NUREG-75/088

# **environmental statement**

## **PERKINS NUCLEAR STATION, UNITS 1, 2, and 3**

**DUKE POWER COMPANY**

Fig. 2.1. Site layout - Perkins Nuclear Station. Source: ER, Fig. 3.4.0-1, Amend. 3.

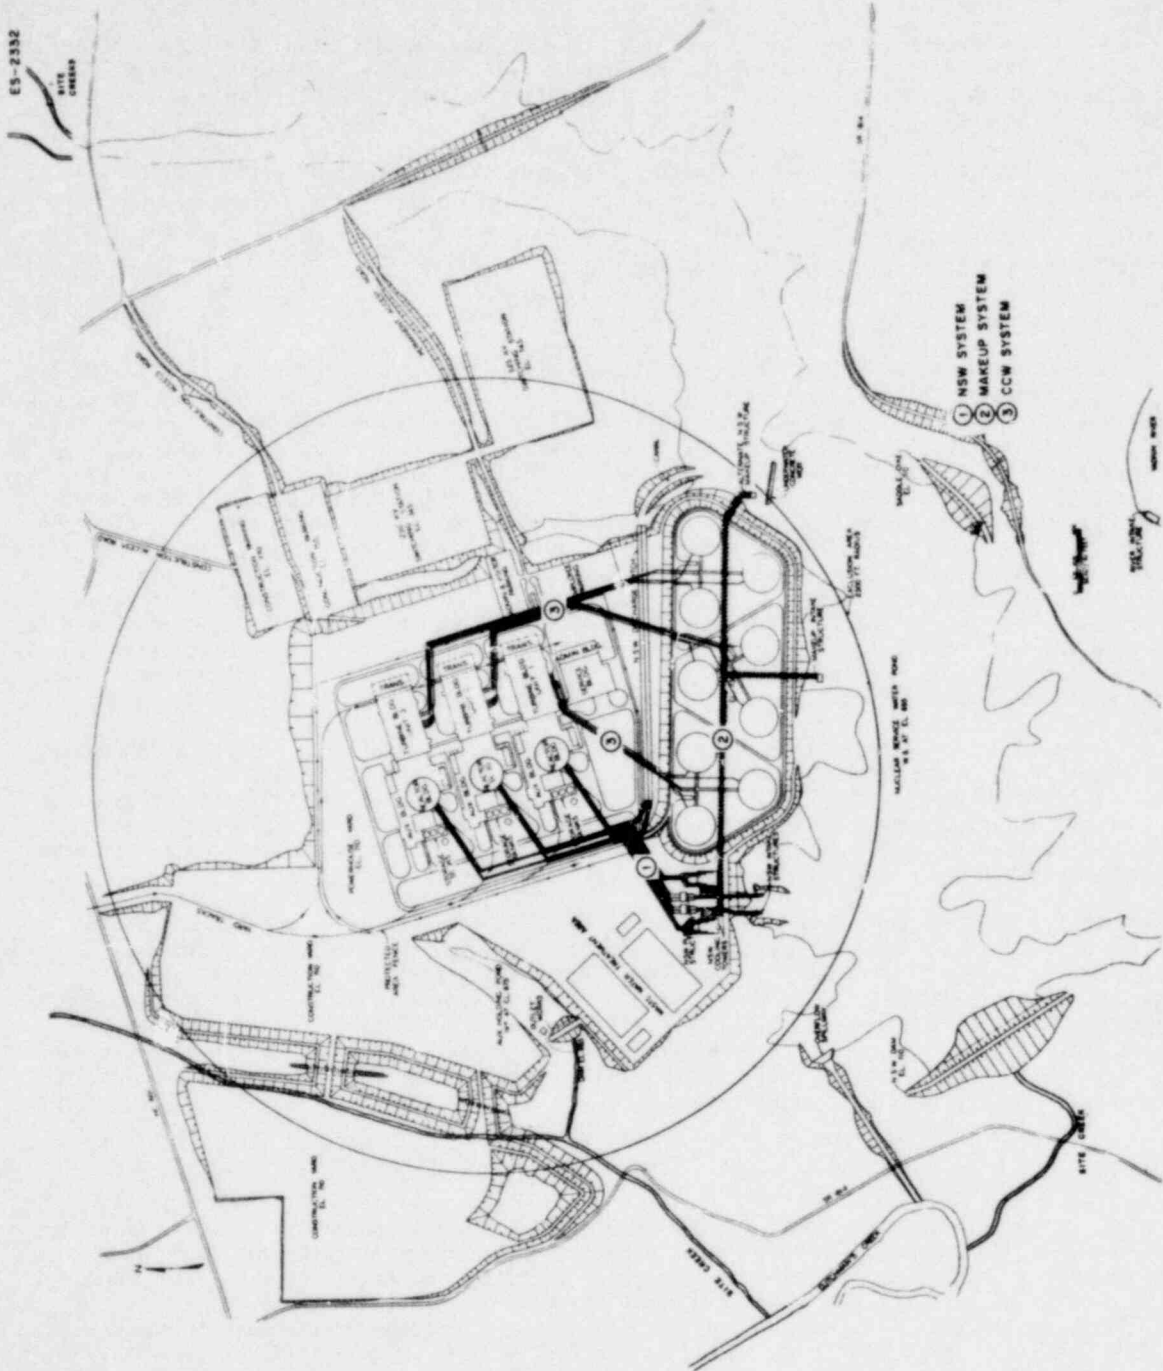
The source (ER Figure 3.1.10-2) of DES Figure 2-1 has been revised by Amendment 3 of the Perkins ER.

Fig. 2.4. Major features of the area within a 50-mile radius of the proposed Perkins Nuclear Station.

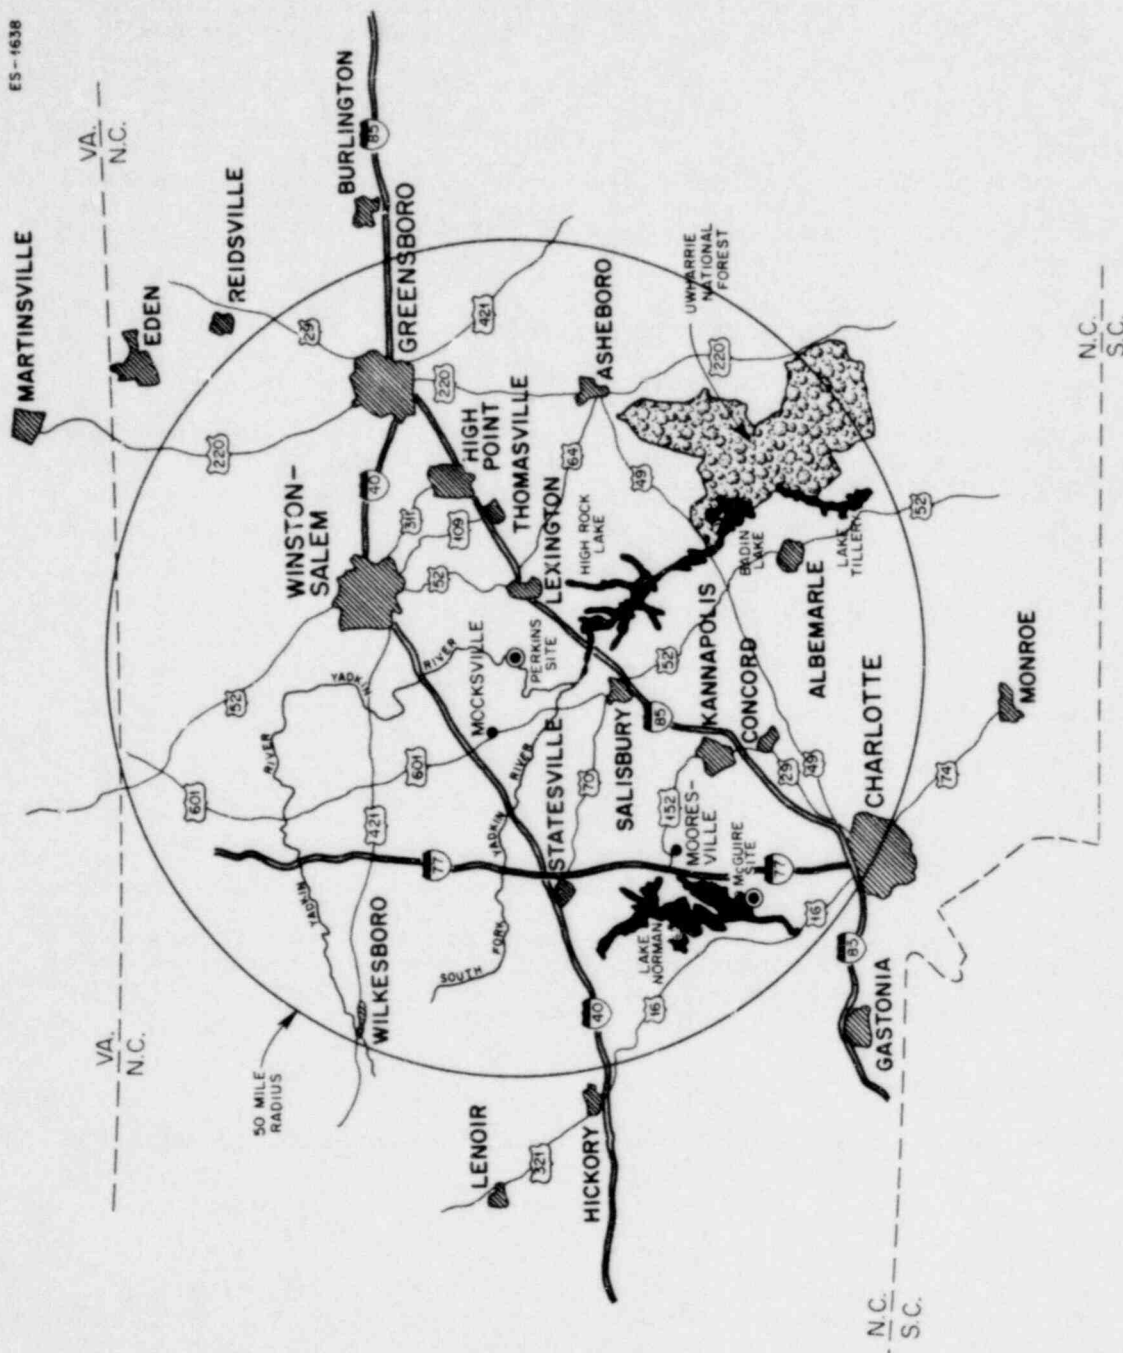
On page 2-5, reference is made to Boone's Memorial State Park and Cooleseemee Plantation Game Land. In the final statement, both of these areas should be shown on Figures 2.4 and 3.7. This would not only clarify any reference to these areas but would also substantiate the statement that no recreation and wildlife areas would be crossed by transmission lines.

Figure 2.4 is too small scale to include the above recreational facilities. However, Figure 3.7 has been modified to show the outline of the portion of Cooleemee Plantation that the proposed transmission line crosses and also Boone's Memorial Park. The text has been revised to show that the Winecoff-Beckerdite tie-in does cross game land that was leased by the state from Duke. The lease has expired but will be renewed if the state desires to do so. In any case Duke will permit hunting on the land. To avoid any visual impact to the Cooleemee Plantation House itself north of the river, there is a "vista easement" (ER, Figure 3.9.3-1) to protect scenic and aesthetic values.

Fig. 3.5. Liquid radioactive waste system, Perkins Nuclear Station Units 1, 2, and 3.

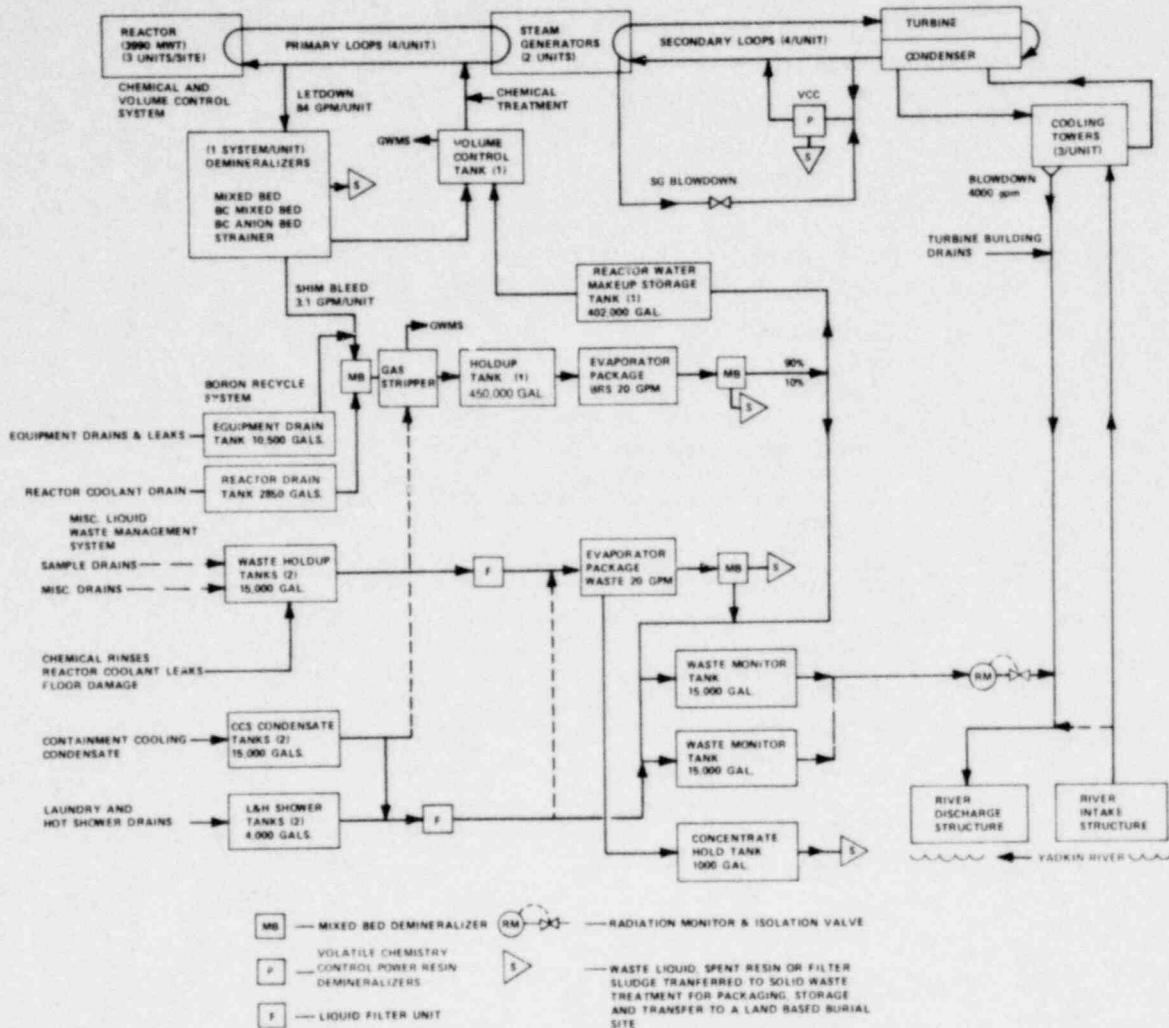
Figure 3.5, Liquid Radioactive Waste System Schematic Diagram, shows turbine building drains, cooling tower blowdown and monitored radwaste tanks all flowing through one pipeline to the Yadkin River Discharge Structure. To clarify Figure 3.5, the following items are noted:

- 2) Cooling Tower Blowdown flows through a separate 21-inch diameter pipe in the river discharge structure and there are three cooling towers/units rather than the configuration shown on Figure 3.5.

- 4) Figure 3.5, Liquid Radioactive Waste System shows VCC (Volatile Chemistry Control) Powered Resin Condensate Polishing Demineralizers with spent resin transferred to solid waste treatment for packaging, storage, and transfer to a land based burial site. Provisions for handling spent resin, under radioactive conditions are correct. However, non-radioactive condensate polishing resins at Perkins Nuclear Station can be sluiced to the Waste Water Holdup Basin for disposal by sedimentation. (Duke Power Company has operated three nuclear units from startup through May 1975 with no leakage of primary system radioactivity into the secondary steam-condensate systems. Spent condensate polishing resins have remained non-radioactive.)

Fig. 5.4. Staff's estimate of drift deposition due to operation of cooling towers at Perkins Nuclear Station. The maximum calculated deposition rate was 13 lb/acre-year, which occurred in the SW sector about 1 mile from the towers.

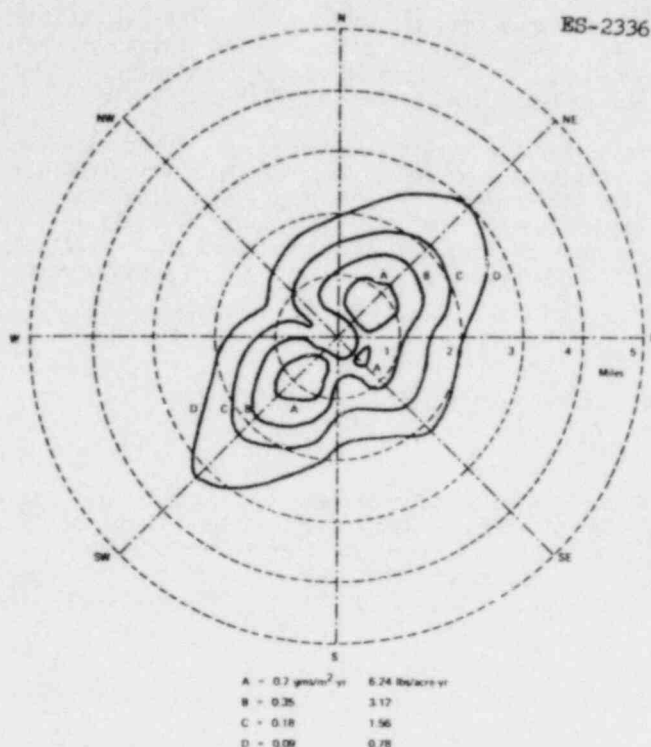
Assuming the average load factor, drift deposition would be 87% of the numbers estimated for Figure 5.2.

Fig. 5.6. River intake and discharge system layout. Source: ER, Fig. 3.4.1-1, Amend. 3.

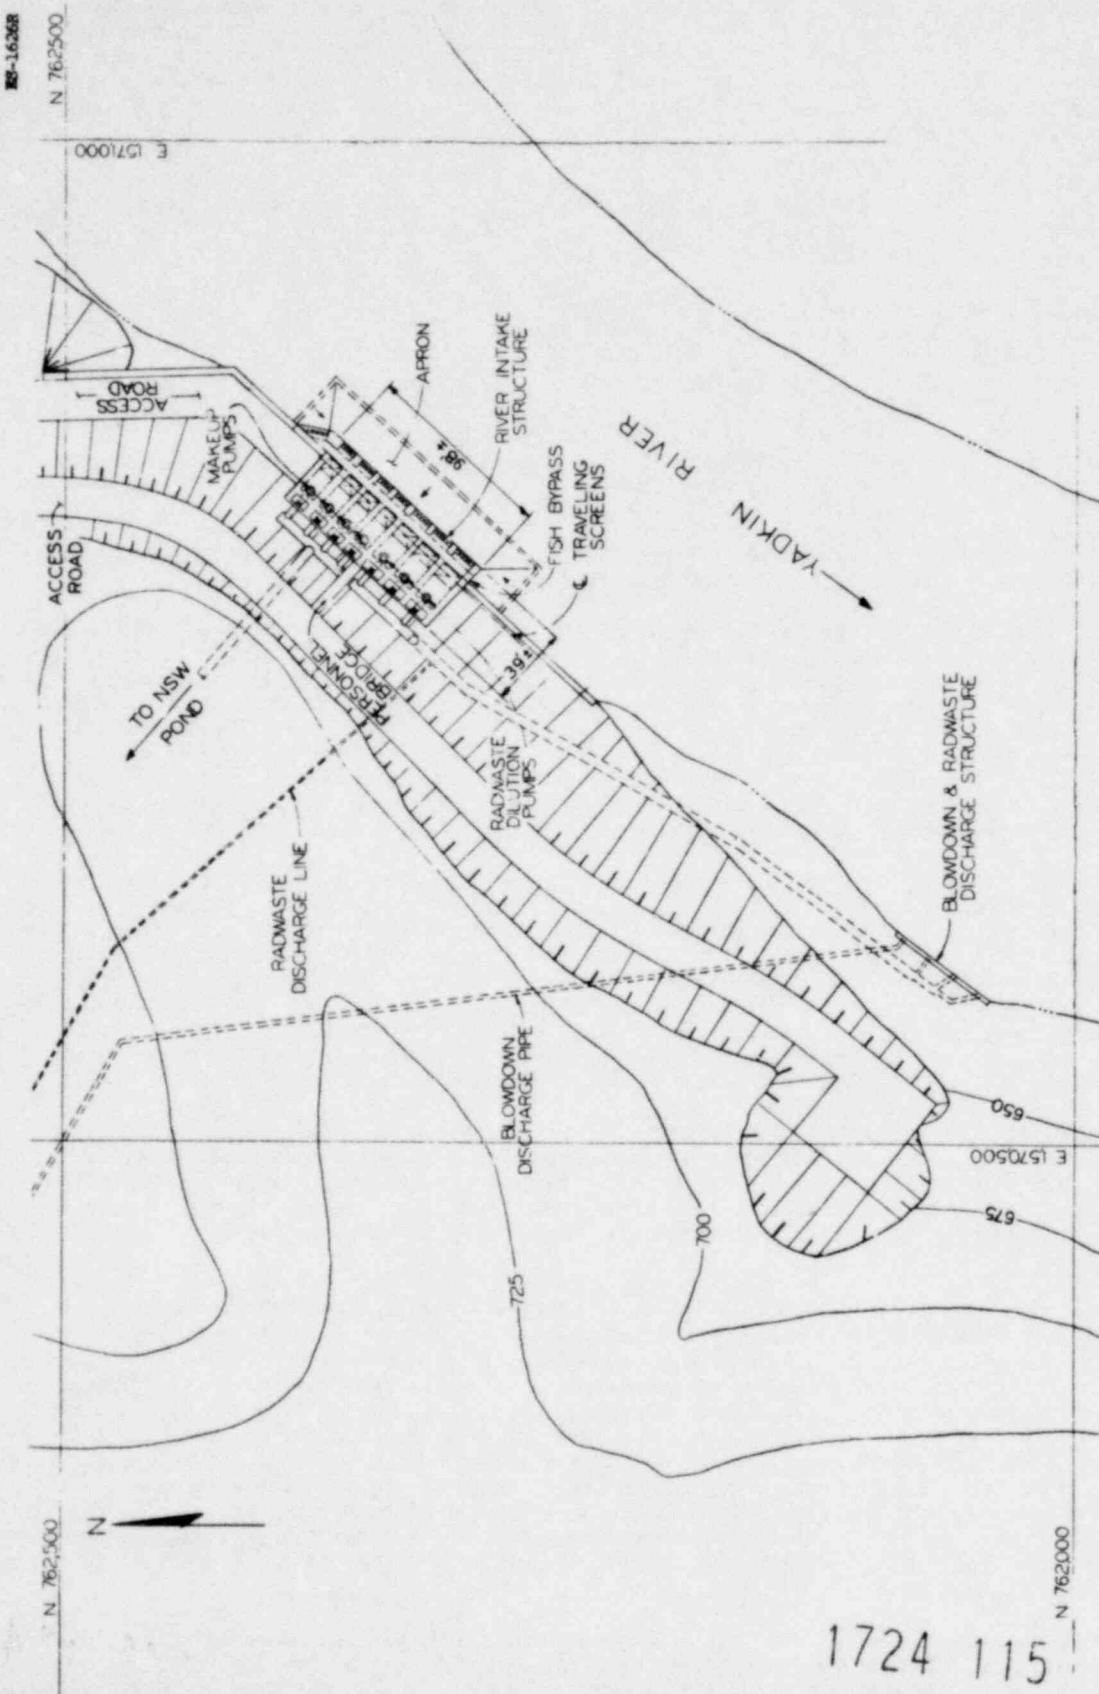
Figure 5.5 in the DES shows the piping and discharge nozzles for the radwaste discharge. This figure appears in the FES as Figure 5.6.

Fig. 5.7. Summary of residual chlorine toxicity.

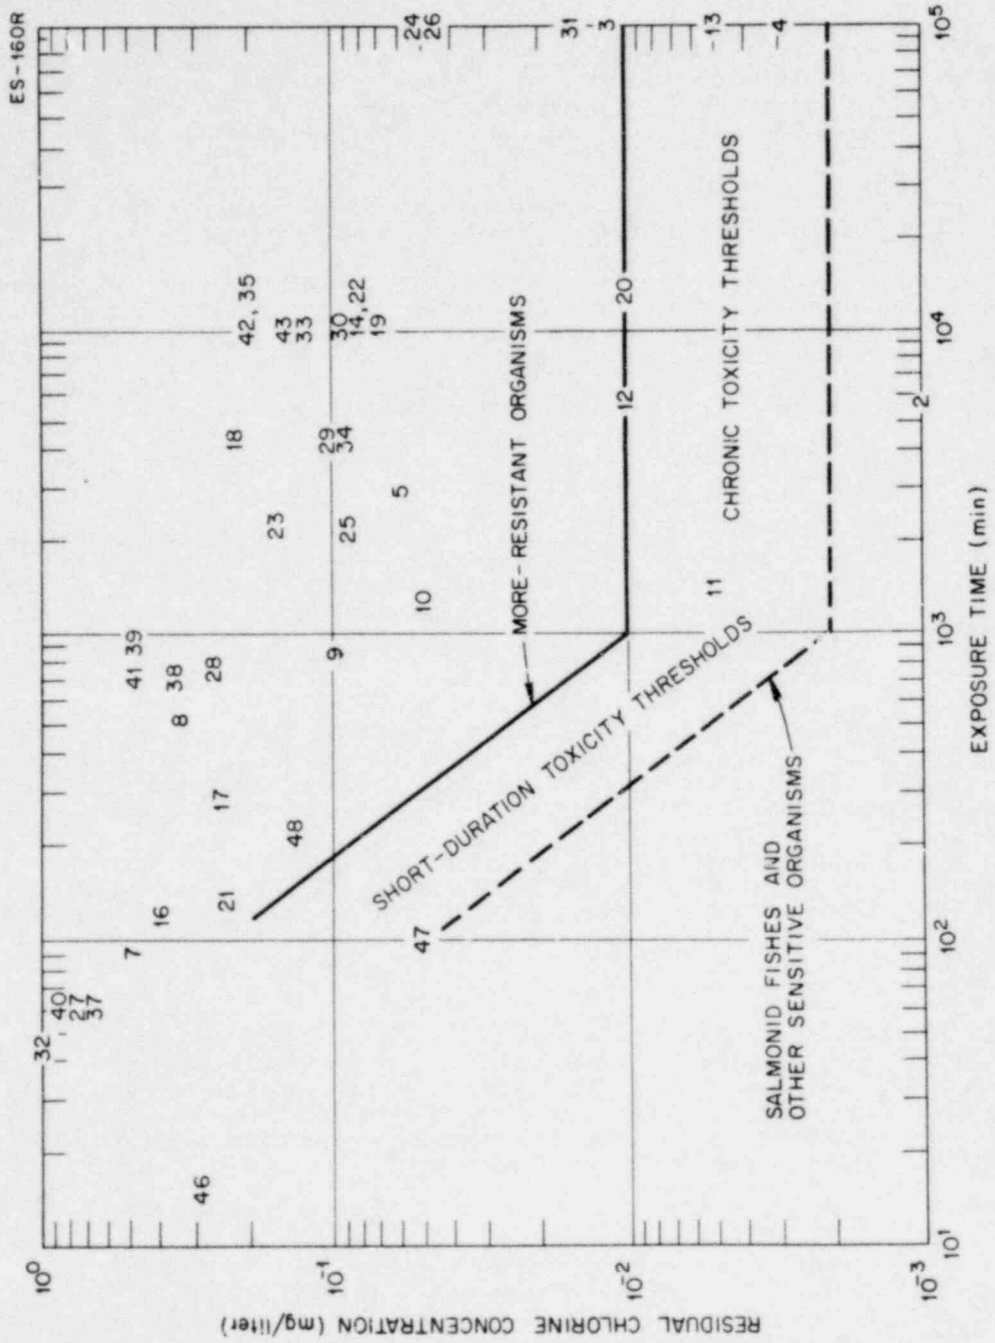
Points numbered 1, 6, 15, 36, 44 and 45, listed in the key, are not plotted in Figure 5.7.

Figure 1

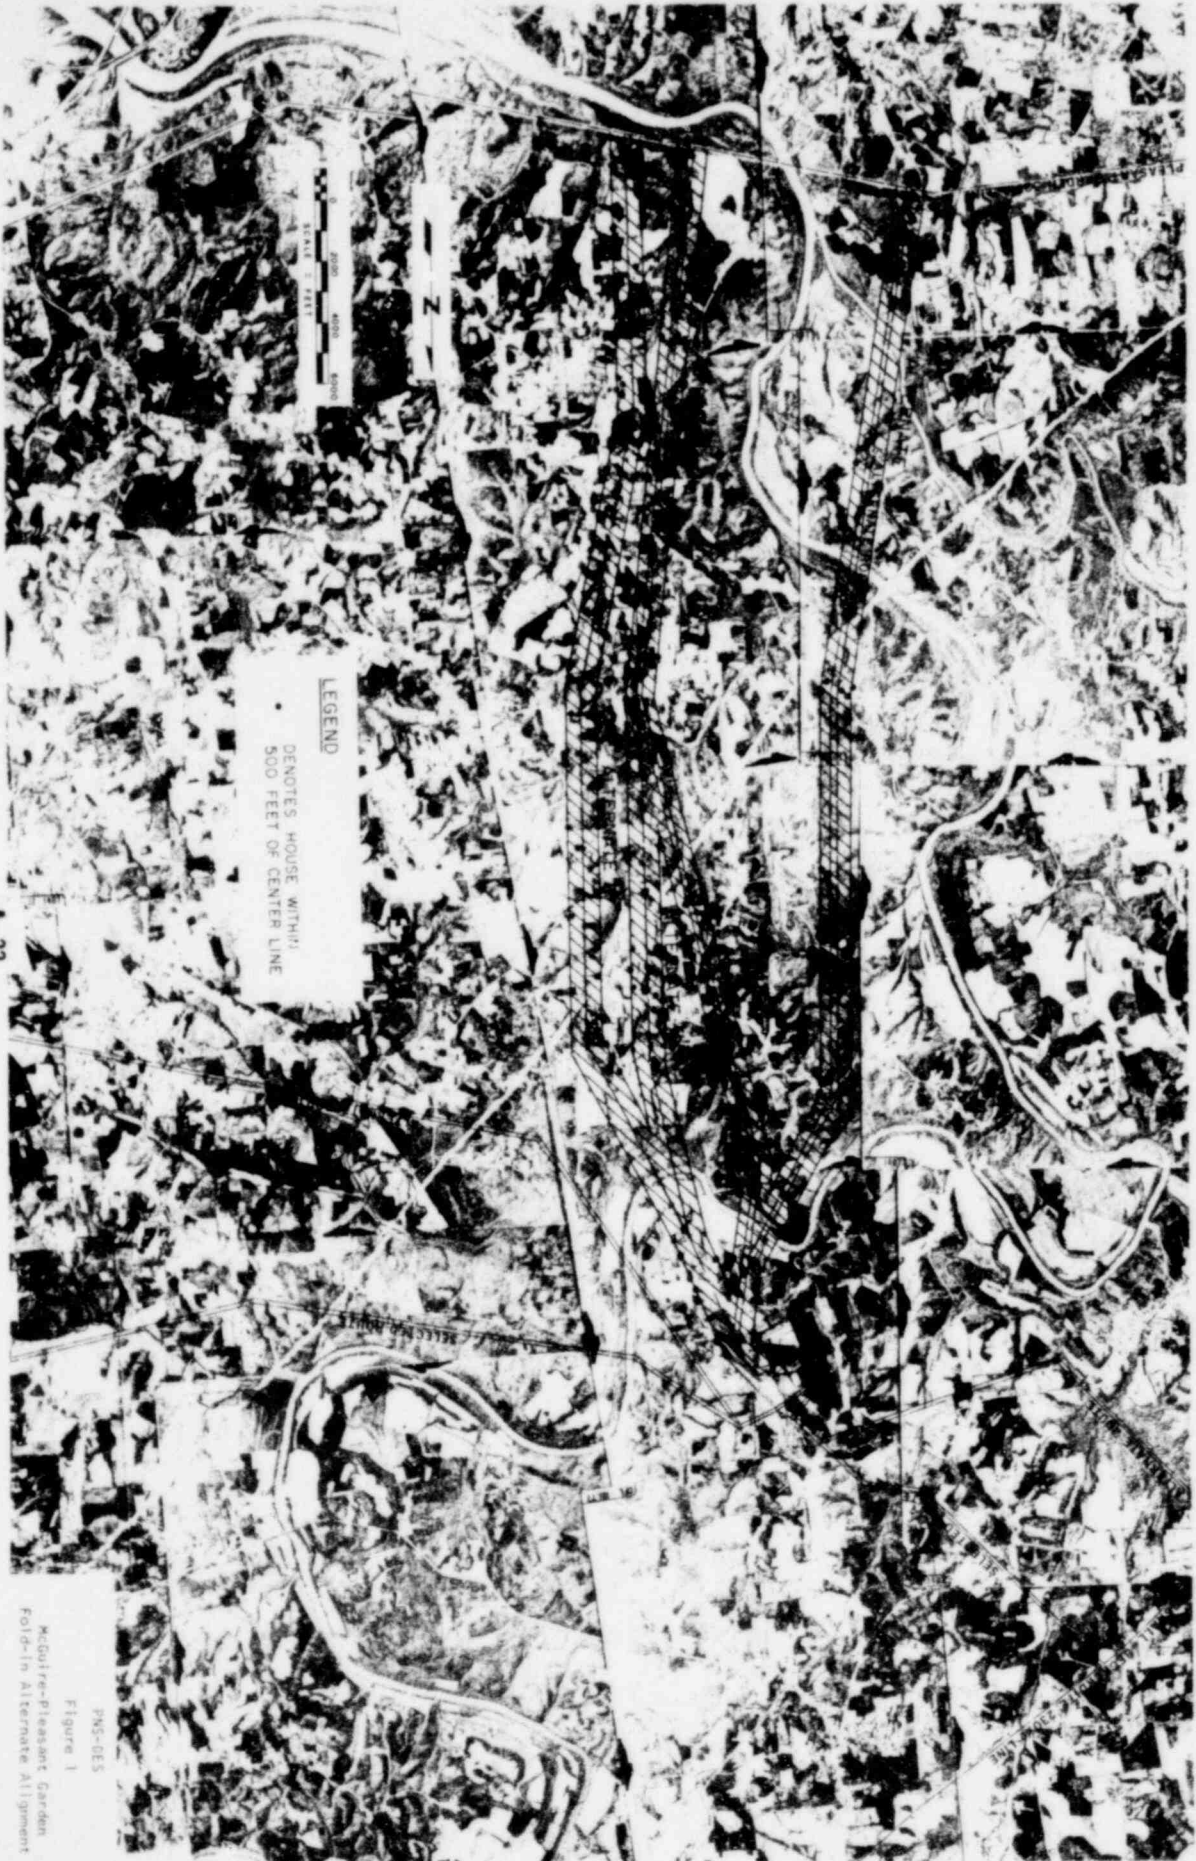
Applicant has made a thorough investigation of two alternate routes located east of the selected McGuire-Pleasant Garden 525 kV fold-in. Although the selected route includes more forested acres (all of which is merchantable), Applicant chose this route because it affects fewer people and has less impact on present and planned land uses of the area (see Tables 1 and 2 and Figure 1 attached to these comments).
